Original

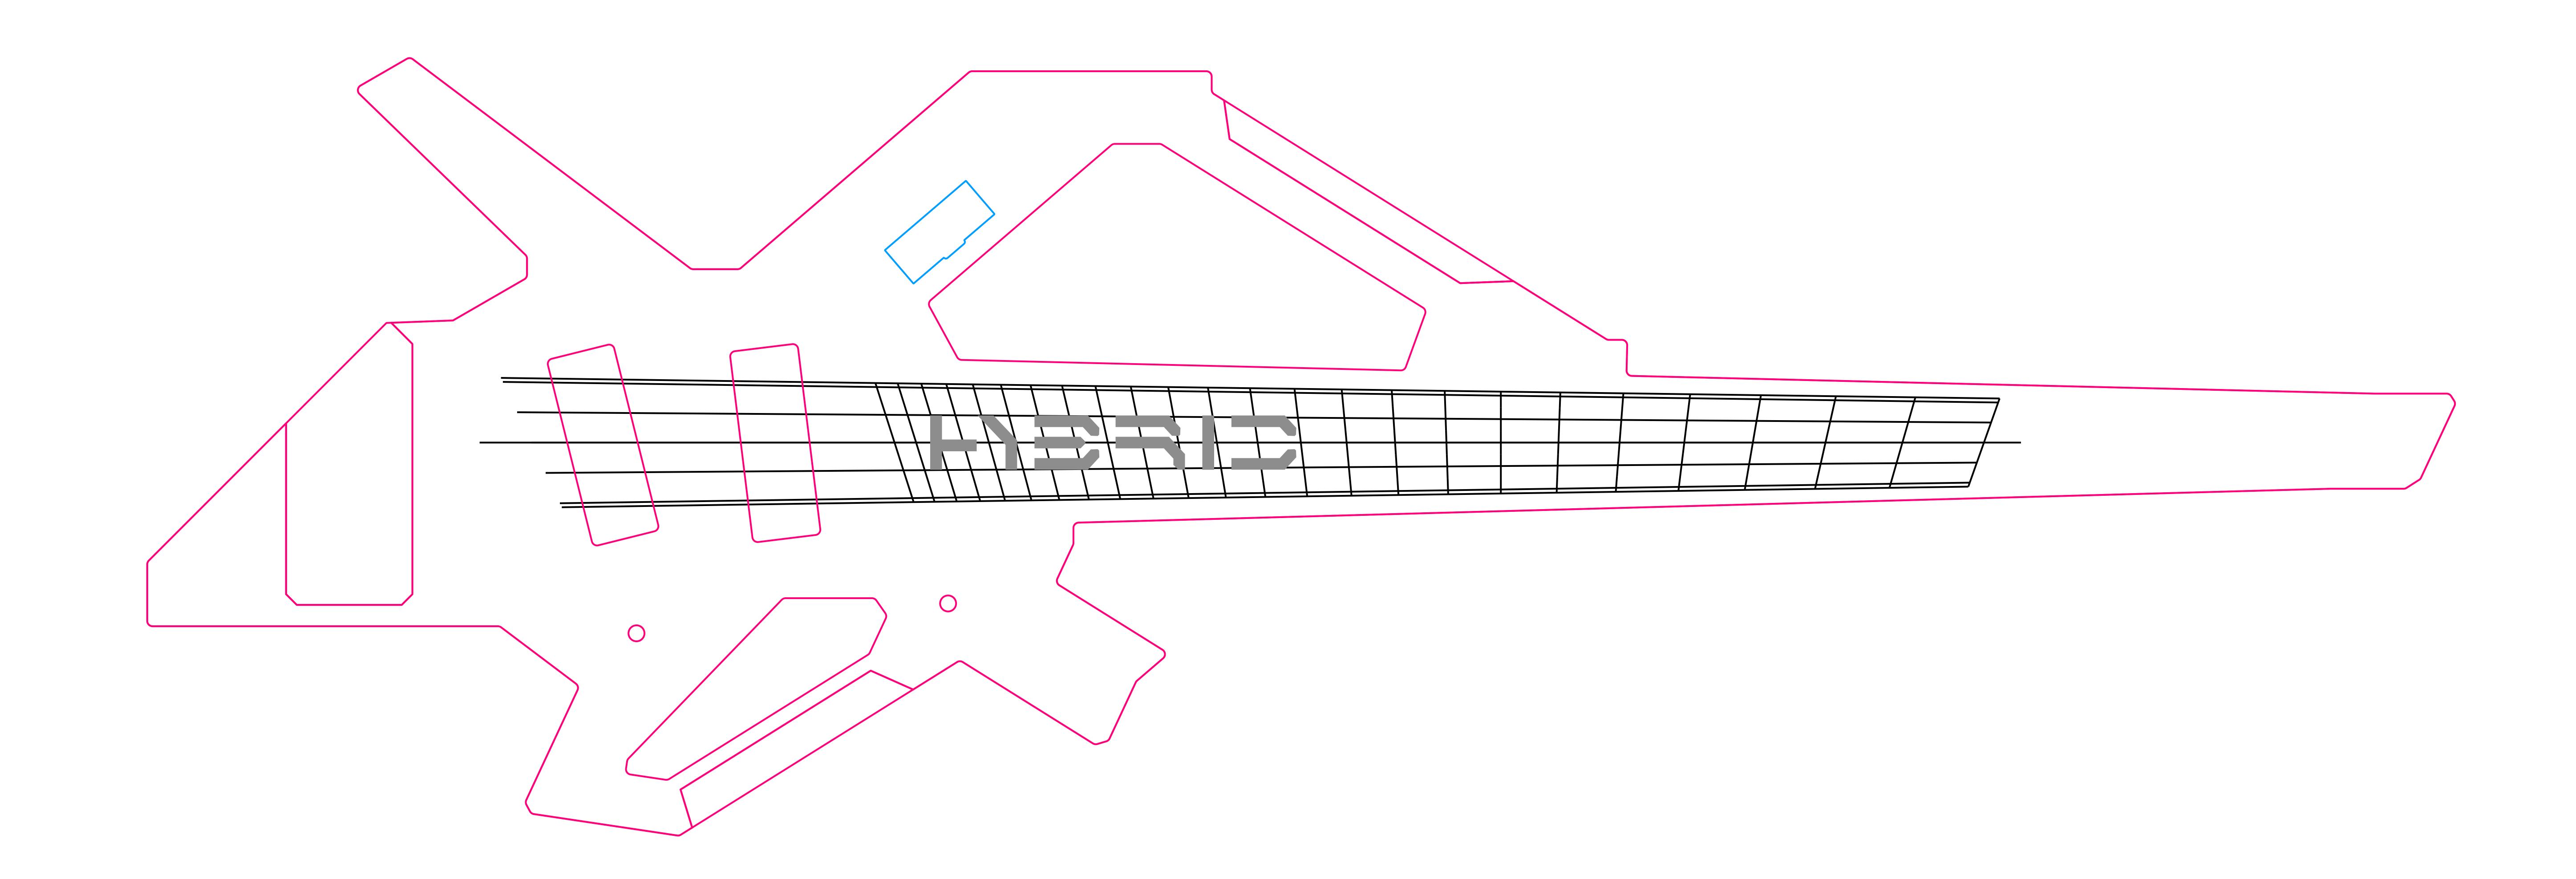
Size mismatch with fretboard, guitar body appears too large

Scale to 85% of original, then shorten fretboard by 2 inches No size change on oscilloscope, switch, and MIDI pickup compartments, or 1/4" knob shaft holes
